## 2.3 STREAM CHANNEL MORPHOLOGY AND AQUATIC HABITAT STUDY (WTS 3)

This section presents stakeholder comments provided on the draft report, followed by the Licensees' responses. The final column presents any follow-up comment offered by the stakeholder and in some cases, in italics, a response from the Licensees.

**Figure 2.3-3. Changes in Lewis River, from Merwin Dam to Eagle Island.**

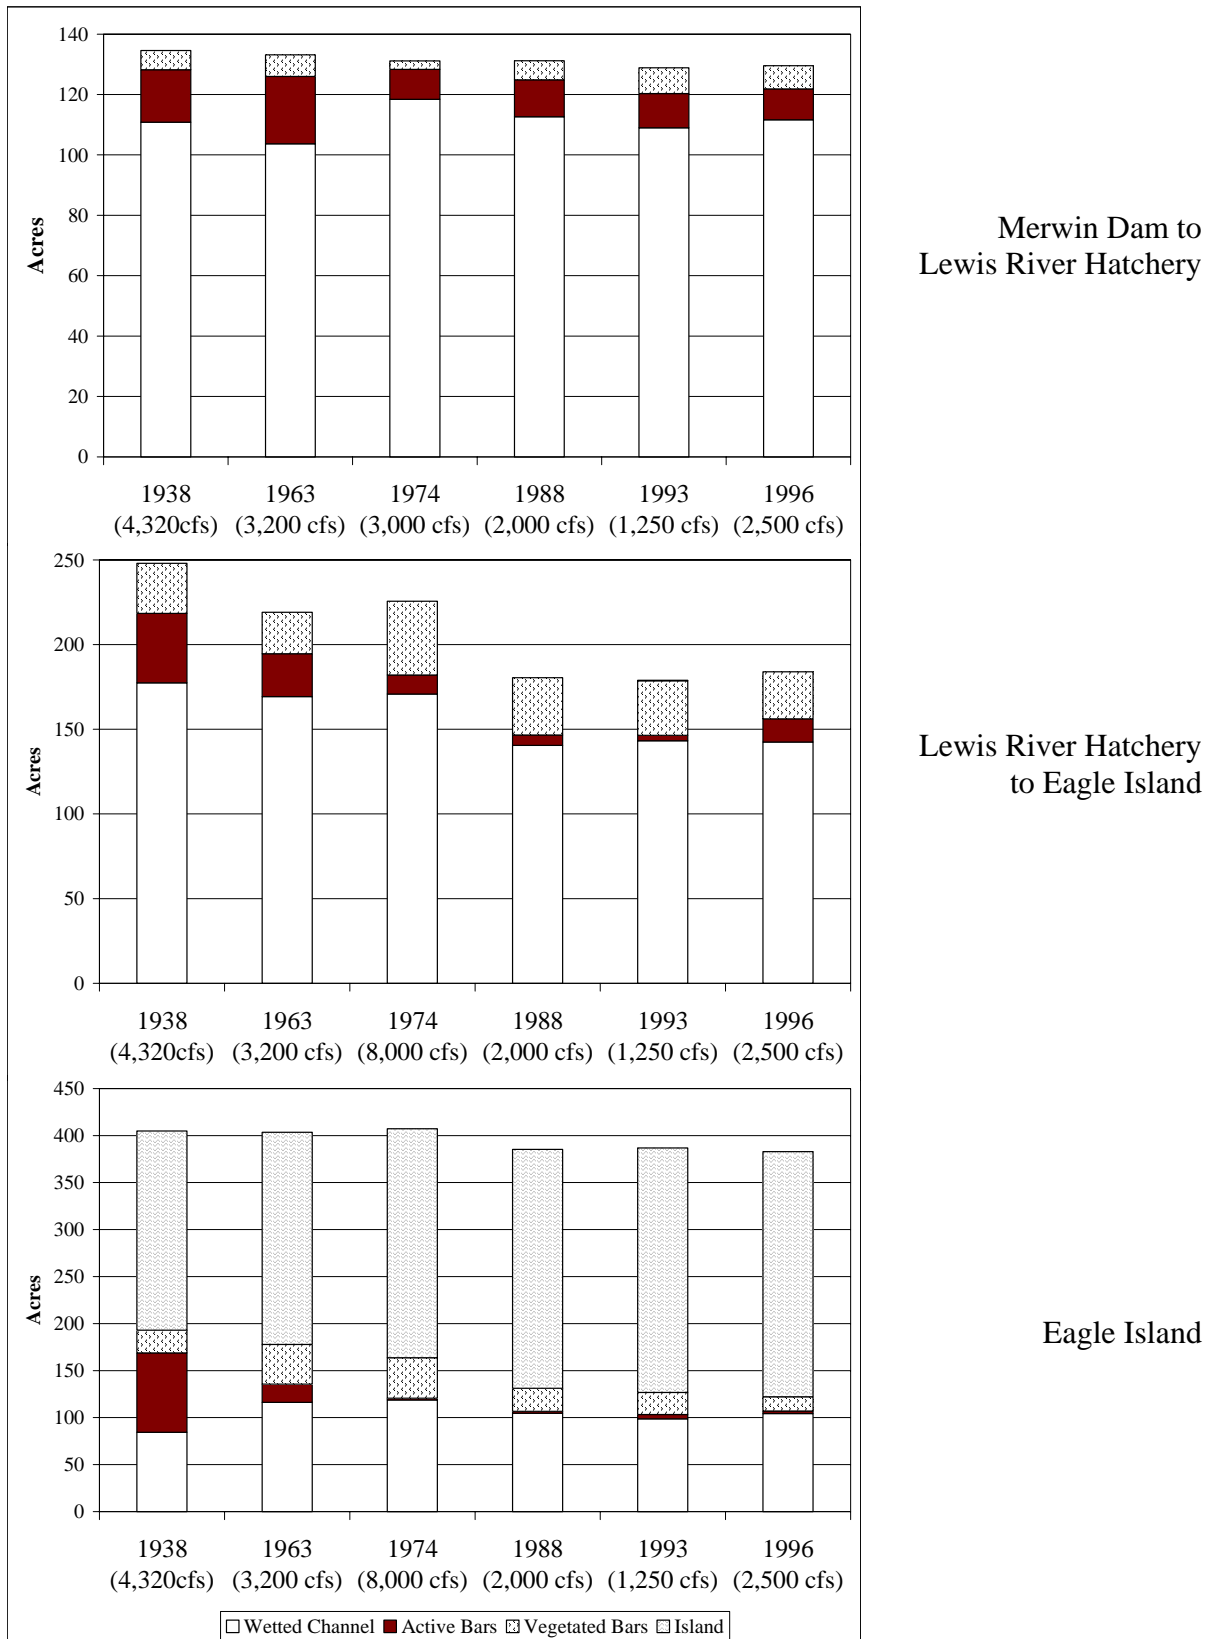
J. Sampson, Technical Advisor to the Conservation Groups	1	WTS 03-48 para 3	“...the acreage of channel features...was obtained from GIS maps of the channel through time (Table 2.3-5; Figure 2.3-3).”	According to the figure referenced, flows at the time of the photographs were variable. For example, at the time of the 1974 photos, flows were 8,000 cfs for part of the reach, and in 1993, flows were 1,250 at the time of the photos. These types of differences suggest that direct comparison of habitat areas between photos is accompanied by some uncertainty. These caveats should be noted to the reader, and their implications on the findings should	There is uncertainty in direct comparison of the photos associated with differences in flow, primarily the 1974 photos in the middle and lower reaches. This will be described in the text.

Commenter	Volume	Page/ Paragraph	Statement	Comment	Response	Response to Responses
					presented in the text, provides us with cumulative evidence pointing to the conclusions we reached.	
WDFW – KAREN KLOEMPKE N	1	WTS 03-55 Fig. 2.3-3	Changes in Lewis River.	Missing X axis title.	The x-axis shows the year of each aerial photograph mapped.

Commenter	Volume	Page/ Paragraph	Statement	Comment	Response	Response to Responses
				be stated. For example, in 1974 flows in the middle section of the reach were 8,000 cfs when the pictures were taken. With 8,000 cfs flows, some of the bar and island habitat would be under water. If so, the difference in habitat area between 1974 and 1988 actually represents an even greater habitat loss than would be apparent if the flows were equal for both photos. The effects of the uncertainties in the analysis need to be made explicit to the reader.		
WDFW – JIM BYRNE	1	WTS 03- 48 – 58	Pagination.	Pagination is incorrect, missing pages 78-91.	Figure 2.3-12 (a-f) is presented on these pages. These are 11X17 figures.	Very confusing.
